SUMMARY INDEX
HISTORIC DISTRICTS REVIEW BOARD

MINUTES OF THE
CITY OF SANTA FÉ
HISTORIC DISTRICTS REVIEW BOARD

July 23, 2013

SOUTH ELEVATION

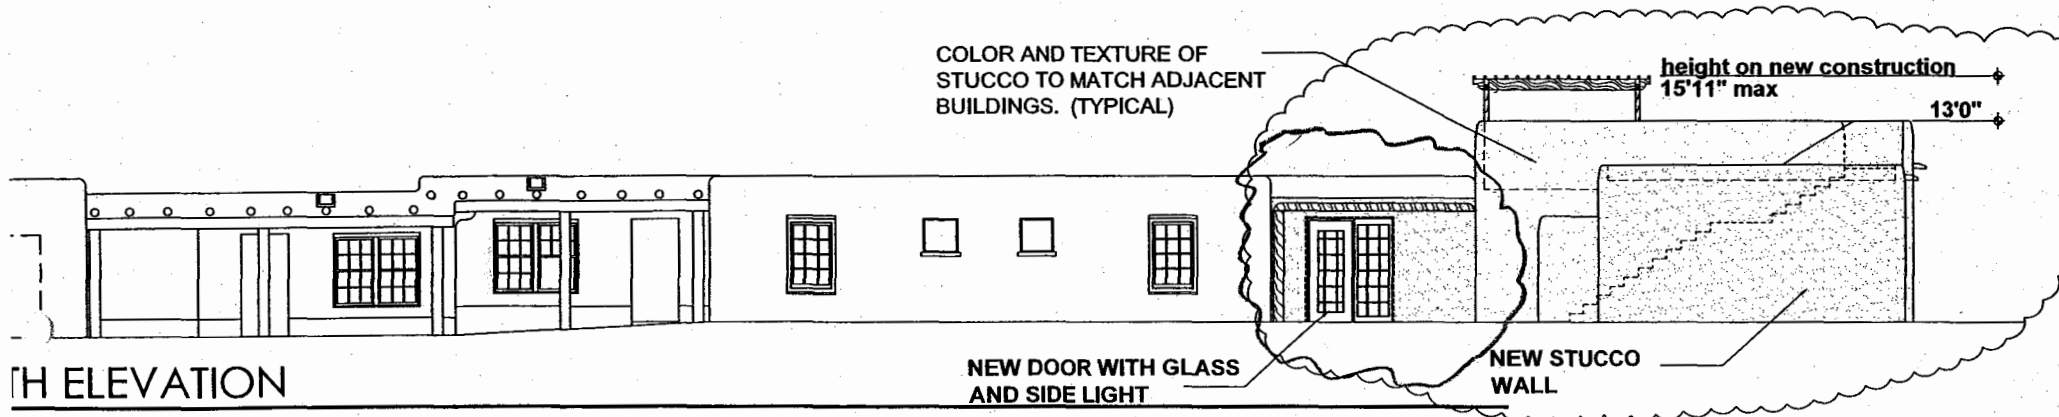
Mr. Boniface asked why the windows on south were so high.

Mr. Purvis said it was to have a view over the walls.

NORTH ELEVATION

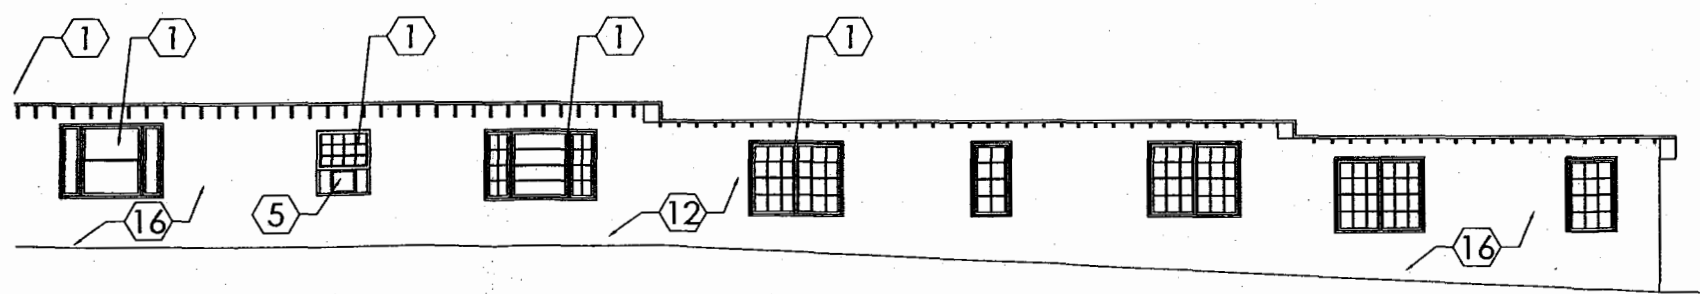
Mr. Boniface asked if the north was not publicly visible. Mr. Purvis agreed.
